## Service Bulletin 14

(a) Service Bulletin No.:	14
(b) Revision / Date	Revision 0 - 12 June 2006
(b) Title:	Colt Propane Cylinders - Liquid off-take fitting inspection
(c) Description:	Detailed visual inspection of weld at the base of the liquid off-take fitting.
(d) Applicability:	All hot air balloon types and variants where Colt V20, V30, V40, H20, H30, H40, H55 propane cylinders are fitted where the liquid off-take incorporates an integral mounting flange for a Quick Shut Off (QSO) system. All Thunder & Colt Hot Air Airship types and variants as above.
(e) Effectivity:	All CN's

Figure 1

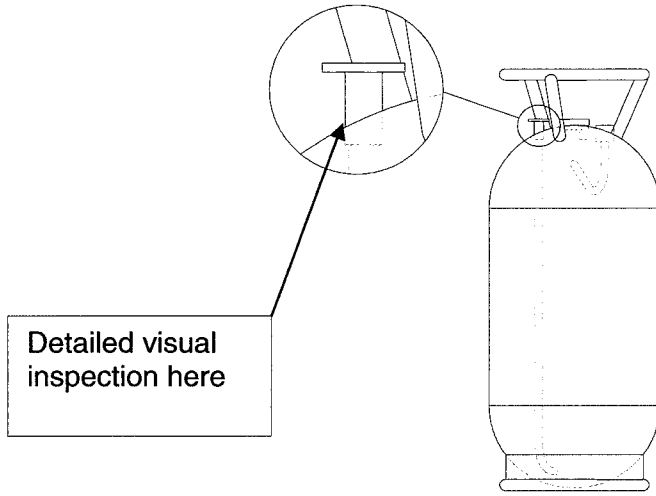
1. Detailed visual inspection of cylinder(x5 magnification with suitable light source) through 360° at weld between cylinder shell and QSO mounting flange. Refer to Figure 1.
2. Reject any cylinder showing signs of cracking.
3. Report any rejections to Cameron Balloons Ltd.
4. For cylinders that have not yet been pressure tested in accordance with the 10-year periodic inspection programme, perform the periodic inspection at the next annual inspection.
